## RECORD OF DECISION

EDS-500(5)

PI #661950

### **Bartow County US 411 Connector**

**Figure 1: 2030 Daily Traffic Volumes on US 411 Connector**

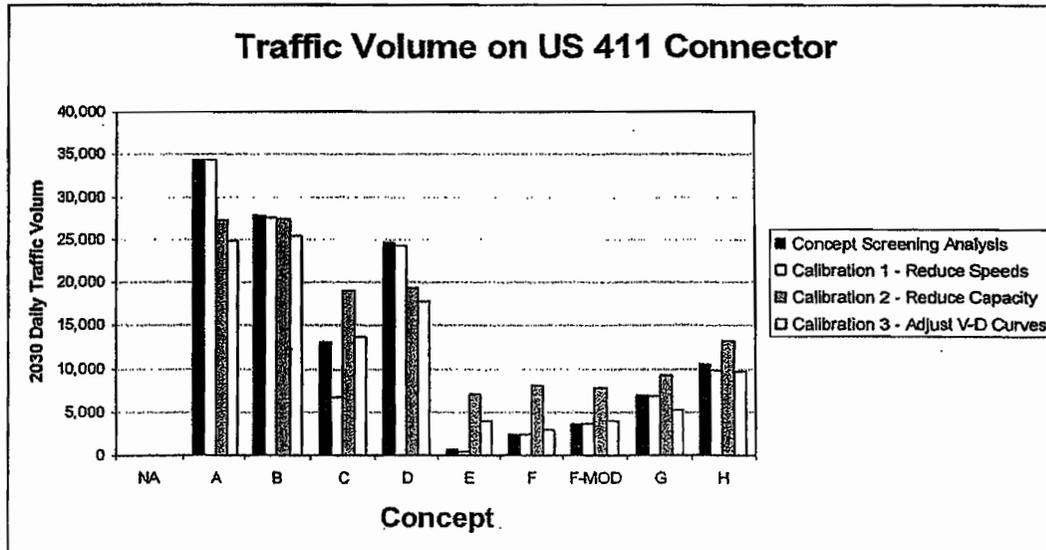
As shown in **Table 2** and **Figure 1**, none of the northerly Concepts (E-H and F-Modified) reach the minimum threshold of 18,900 vehicles per day (vpd) – the minimum volume necessary to justify building a multi-lane highway – under any of the recalibration scenarios. The highest forecasted daily volume on Concepts E, F, and F-modified was 8,100, the highest on Concept G was 9,300, and the highest on Concept H was 13,100.

**Figure 2: 2030 Daily Traffic Volumes on US 41 (the "existing route")**

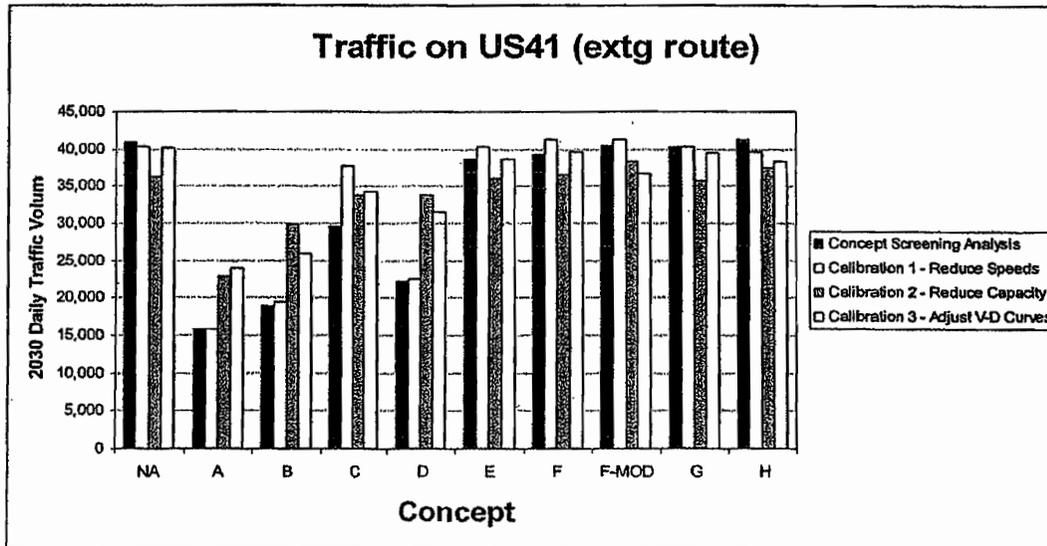
Furthermore, as shown in **Table 3** and **Figure 2**, none of the northerly Concepts relieve the existing route enough to allow the existing facilities to operate at adequate service levels under any of the recalibration scenarios (daily volumes exceeding 22,000 would require major improvements on the existing route): the lowest forecasted daily volume on existing US 41 under any of the northerly Concepts was just under 36,000.

Map 1. Bartow County Traffic Counts and Network.

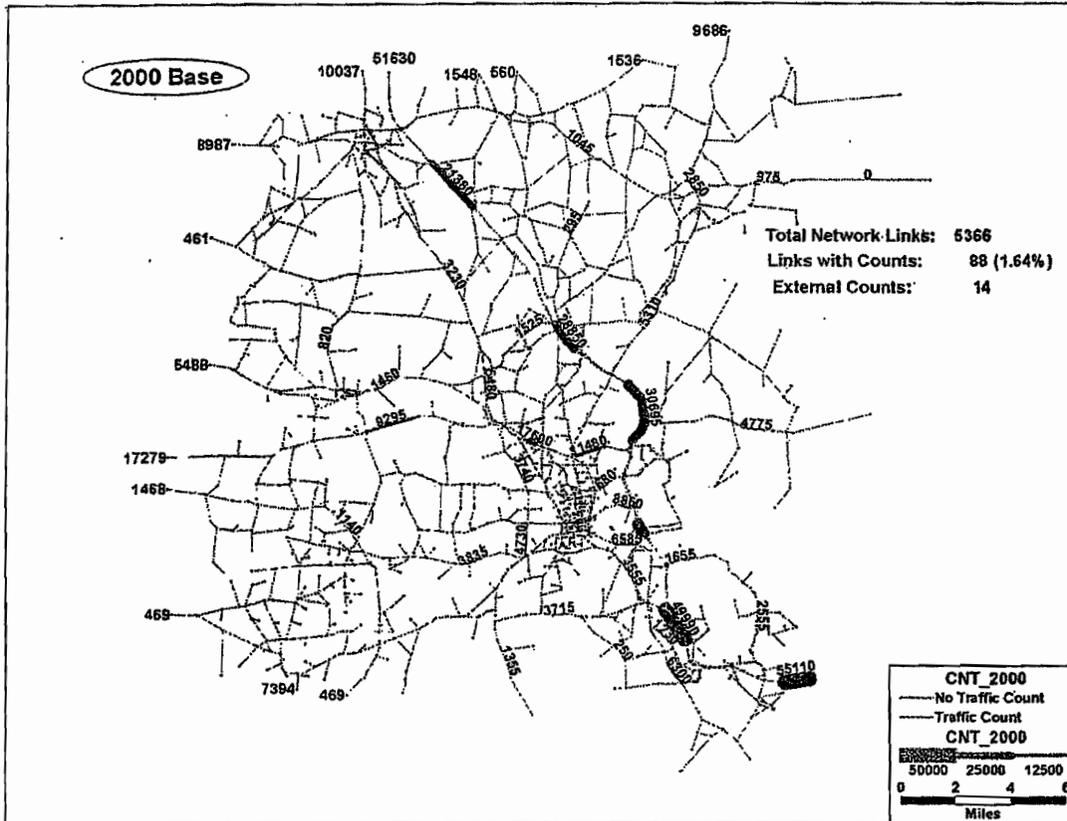
In this case, the model for Bartow County has 5366 links, of which 88 have traffic counts (of these 41 are unique counts). However only 3 counts are on US411/SR41 or SR20. (See Map 1).

**Map 2. Links with Travel Time Adjustments and Congested Speeds.**

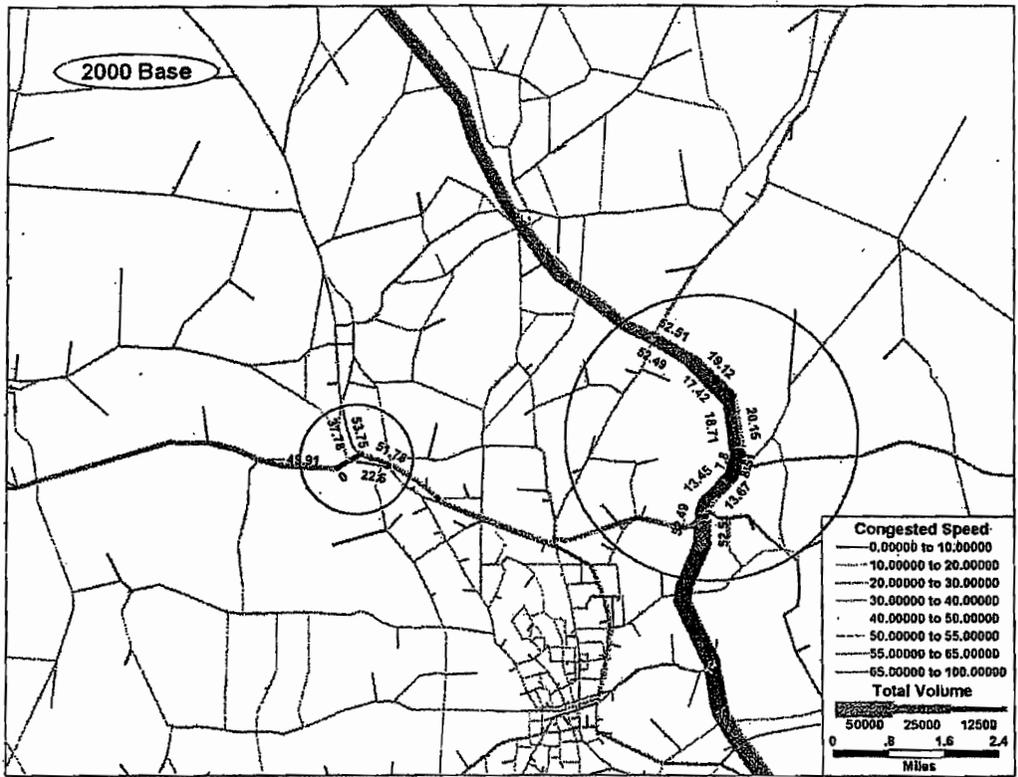
1. **Use of travel time adjustments on 9 specific links, for some tests but not for other tests.**
  - For the first 2-series of base-year 2000 tests of the initial alternatives A-H (conducted in the April-May 2004, and then converted to ESRI shape files in January of 2005), *travel time penalties of about 2 minutes each were inserted onto 8 key links on I75, just north of US 20. For another short link (on US411 just west of SR41) a 'reverse penalty' of zero travel time was applied.* These adjustments created an artificial 'speed well' (sharp drop in speed) on I75 between SR20 and US411 north of Cartersville, and a speed-up of speed through a key intersection on US411 west of Cartersville. See Map 2. We believe that these adjustments were inserted in the calibration process in an effort to 'slow down' I75 relative to other links and thus improve the match between estimated and actual I75 southbound traffic. Similarly we believe that

the travel time reduction on the link on west US411 was made to attract more traffic to US411, thereby better matching the counts on US411.

- The effect of the I75 time penalties (about 6 minutes in each direction for I 75) would be to substantially lengthen travel times for alternatives F-H. Alternatives D and E would be partially affected, D by about 2 minutes, and E by about 4 minutes. C does not reach the Interstate and would not be affected. Alternatives A and B would not be affected.

**Map 3. Alternate F with Congested Speeds and Traffic Volumes.**

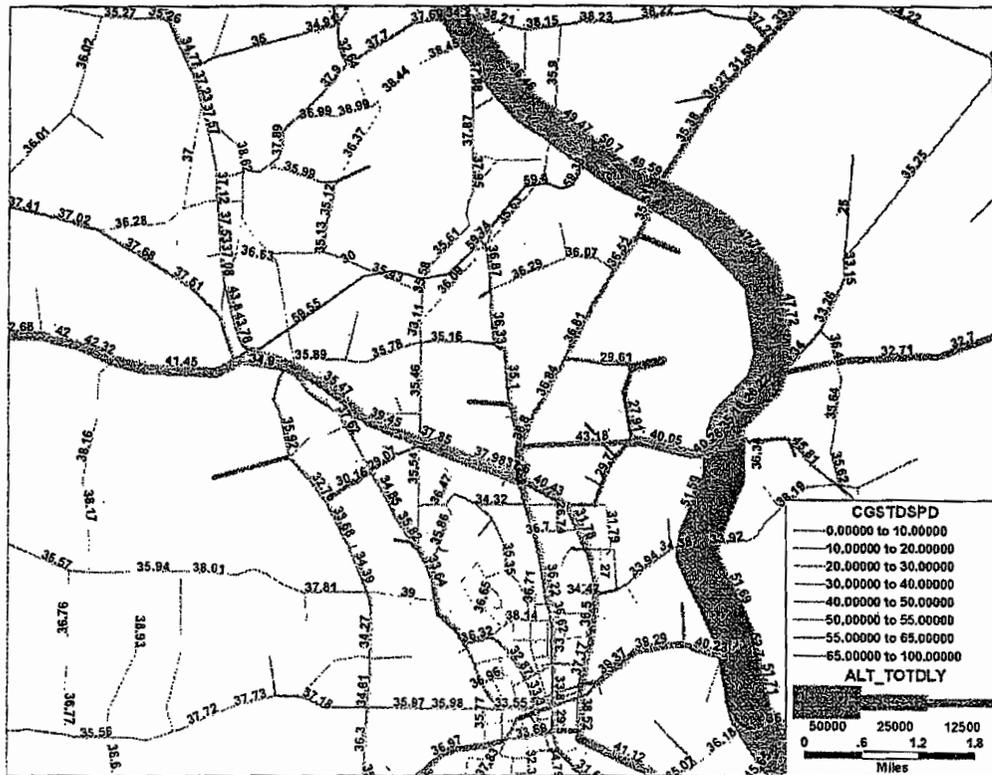
- Our analysis of 'congested speeds' on US 411/SR 41 indicates that for most tests, the 'congested speed' ranges from 35-40 mph. See, for example Map 3. However, if the actual (on the ground) operating speed) is below 30 mph (and might be even lower with the addition of more signals or development), then a modeled (in the network speed of about 30 mph should have been considered in the tests. One way to do this is to do sensitivity tests for speed on US 411, as requested by Kulash (memo, Nov 22, 2006)

analysis indicates that the best estimate for traffic on an alternative is less than 18,600 ADT, then the solution is not to eliminate the alternative from consideration but instead to look at more modest context-sensitive designs which weigh cost versus traffic. We are thinking here of 'super-2' designs (at-grade 2-lanes with wide shoulders, some passing lanes and turn lanes at key intersections), possibly doing 2 lanes of a 'freeway' design now and then adding the other lanes later when volumes increase; 'parkway' and other context-sensitive designs that allow trucks but at lower speeds and tighter geometrics.
